Stage 1 Road Safety Audit and Response Report

**Mowbray Development,
North of Horsham**

Proposed RMA3

Stage 1 Road Safety Audit

Problem Location Plans

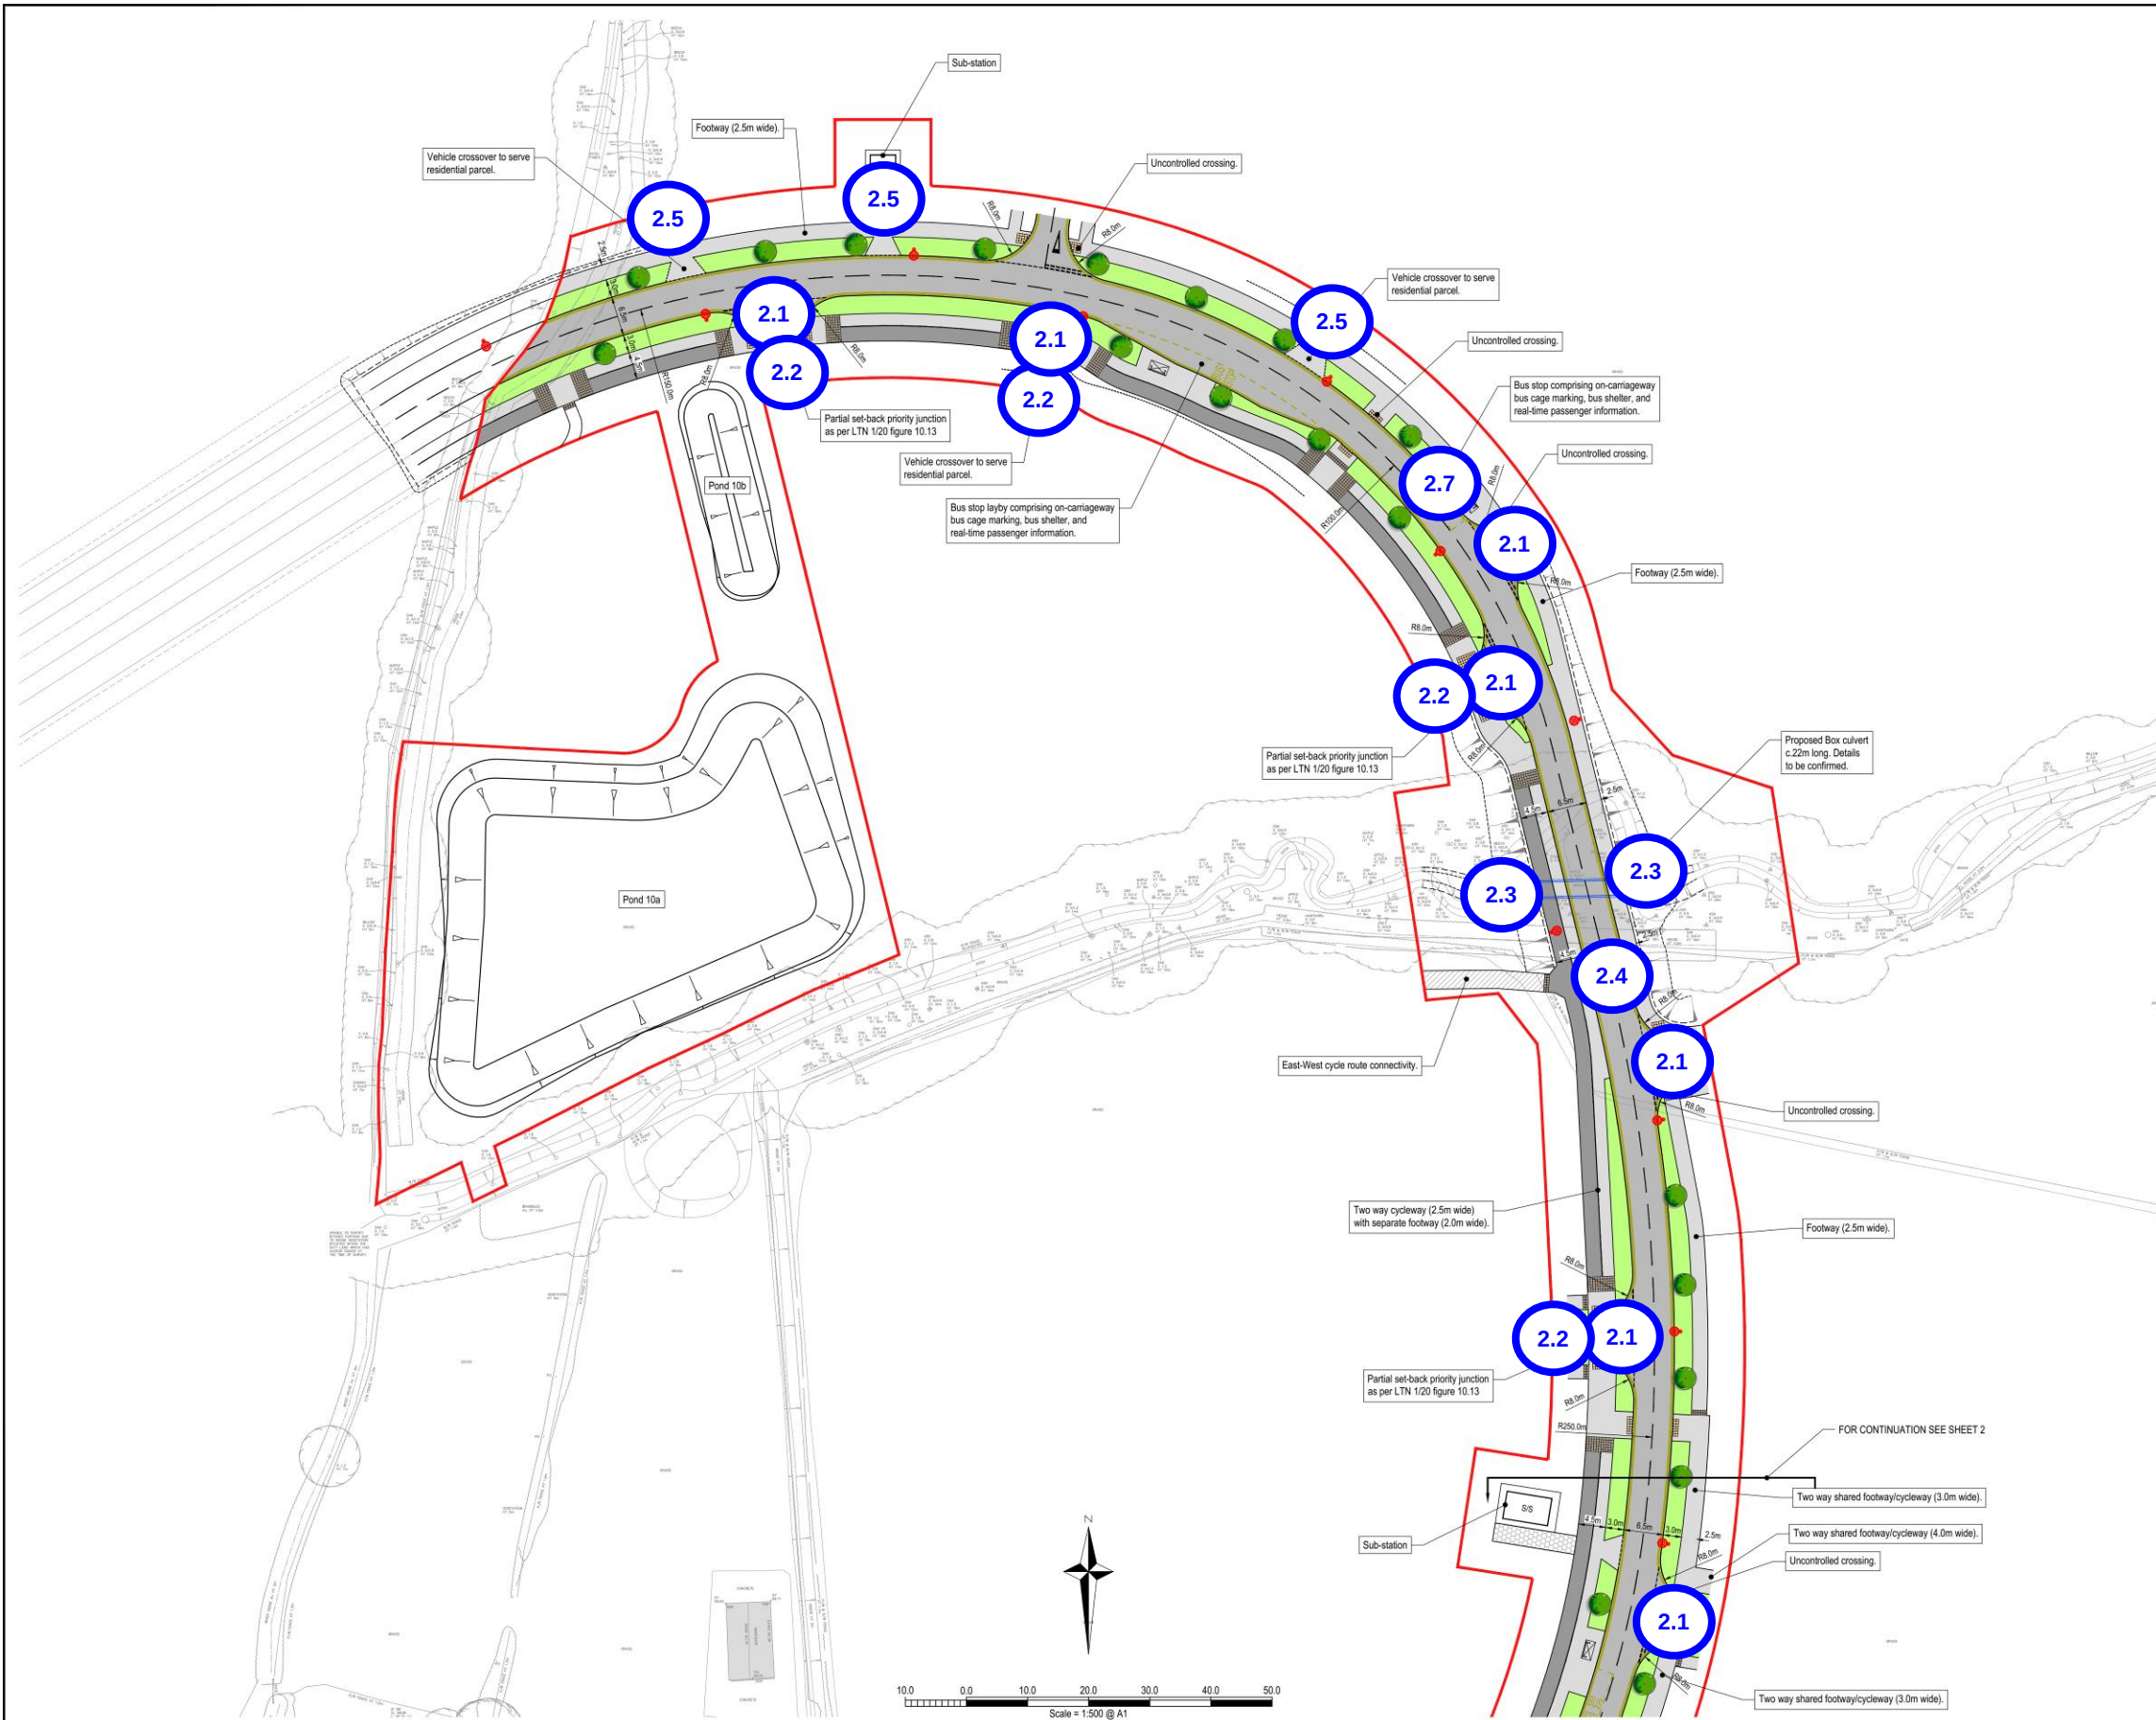
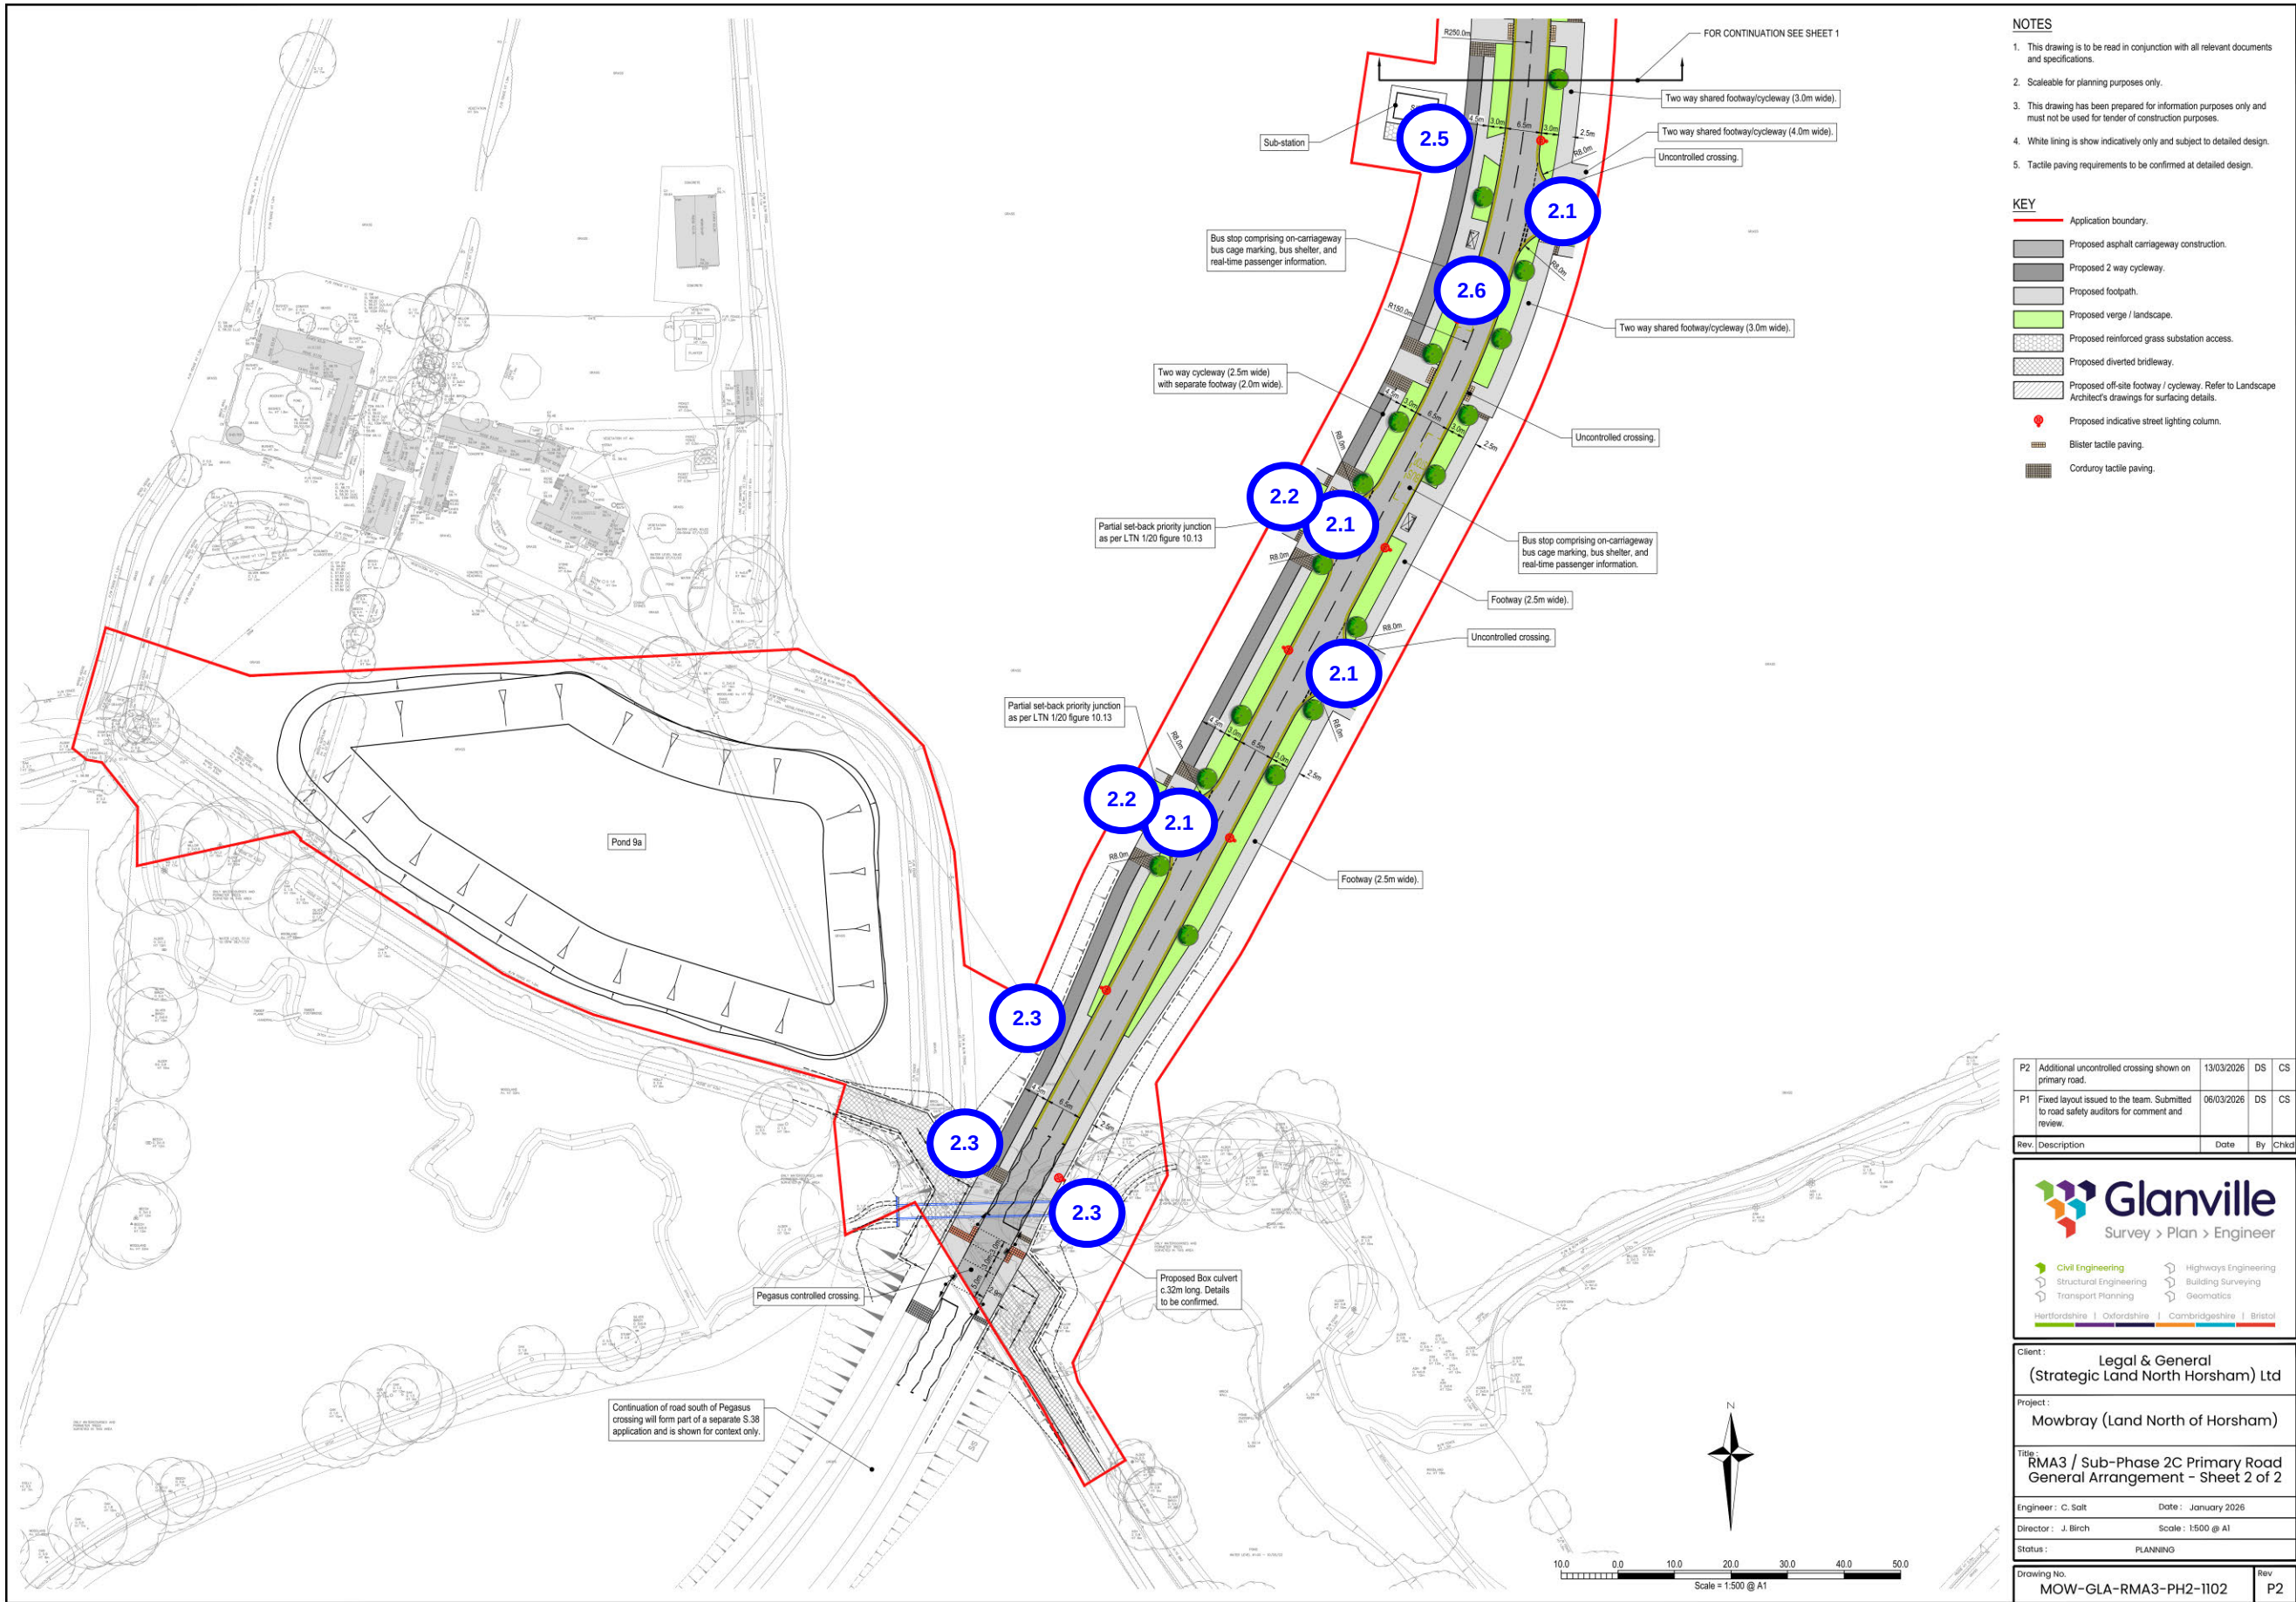
Location: Proposed northbound bus stop

Summary: Potential conflict between opposing vehicles when bus stop is occupied

At the proposed bus stop shown above, it is possible that some northbound motorists may attempt to pass a stationary bus, although they may have limited visibility of any southbound vehicles due to the road alignment. There could also be an added risk of conflict if a vehicle unexpectedly emerges from the side road as illustrated.

It is recommended that the bus stop location is reviewed in light of the potential conflict raised above.

2.6	At the proposed bus stop shown above, it is possible that some northbound motorists may attempt to pass a stationary bus, although they may have limited visibility of any southbound vehicles due to the road alignment. There could also be an added risk of conflict if a vehicle unexpectedly emerges from the side road as illustrated	It is recommended that the bus stop location is reviewed in light of the potential conflict raised above.	The Design Organisation rejects the Audit Team's recommendation. Firstly, it is worth noting that the bus service will operate at a maximum frequency of 2 buses per hour. Secondly, a vehicle attempting to pass will commence its manoeuvre well back from a stationary (northbound) bus rather than immediately behind. Additional vehicle-to-vehicle visibility splays have been added to the layout to clearly indicate what a southbound and left-turning driver will observe and over what distance should a vehicle attempt to pass a stationary bus.
